DRAWING TITLE
BLDG 4 FIRST FLOOR PLUMBING PLAN

PROJECT TITLE
SLVHCS REPLACEMENT MEDICAL
CENTER PROJECT

DRAWING NUMBER
4PL101

1 BLDG 4 FIRST FLOOR PLAN
3/32" = 1'-0"

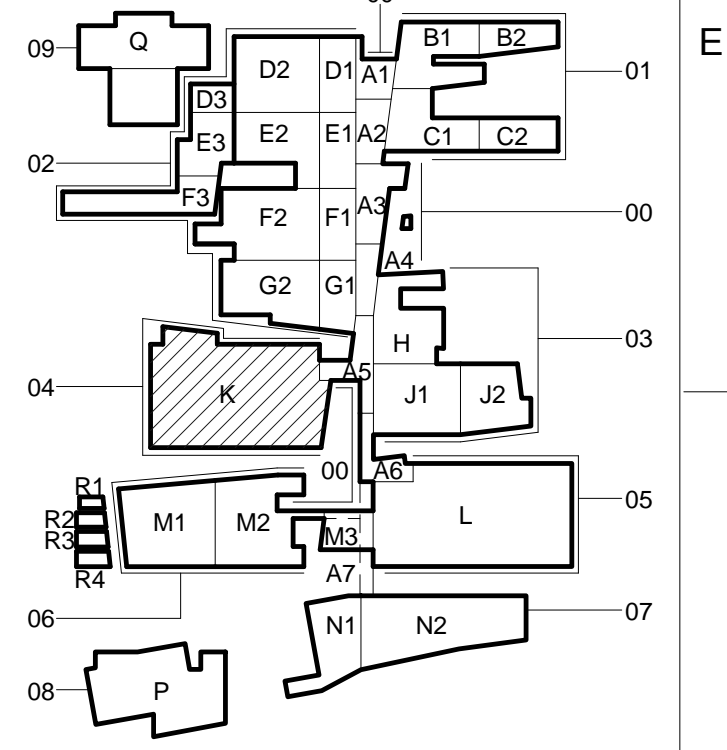
RFI-04364:
Revised Location

SEE RFI 03691:
Revises location of
waste and vent risers.

RFI-05441: As-built
location is acceptable
